SYSTEM/MODEL: LEF

MODIFICATION: Separate transmit and receive volume controls

SEPARATE TRANSMIT AND RECEIVE VOLUME CONTROLS (LEF-10)

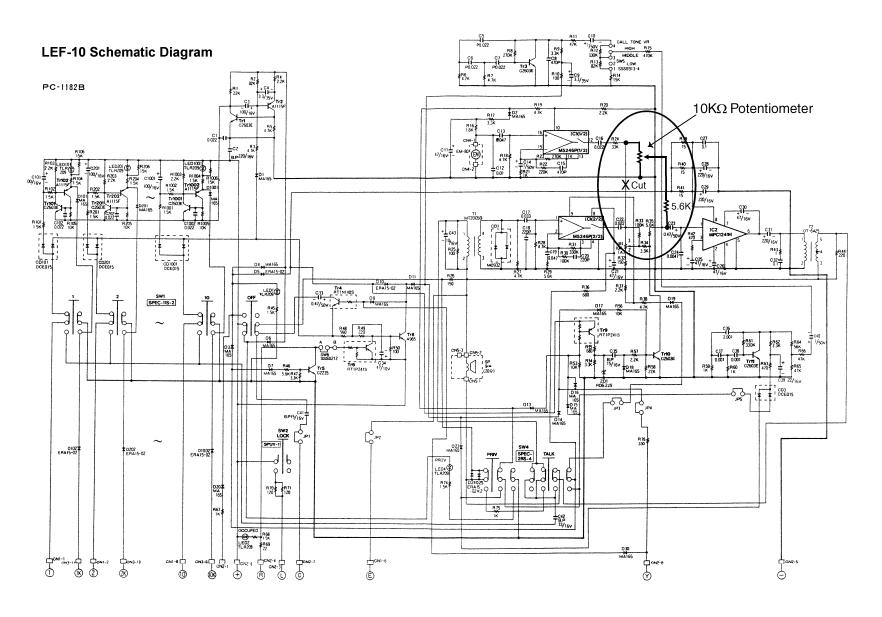
INSTR/OPERATIONS: 1. Install potentiometer and resistor as shown on schematic.

- 2. Cut trace as shown on schematic.
- 3. Potentiometer will lower outgoing volume. Main volume control on the master will control the overall volume in both directions.

Add components as shown above. Cut trace where marked with an X. Potentiometer will lower outgoing volume. Main volume control on the master station will control the overall volume in both directions.
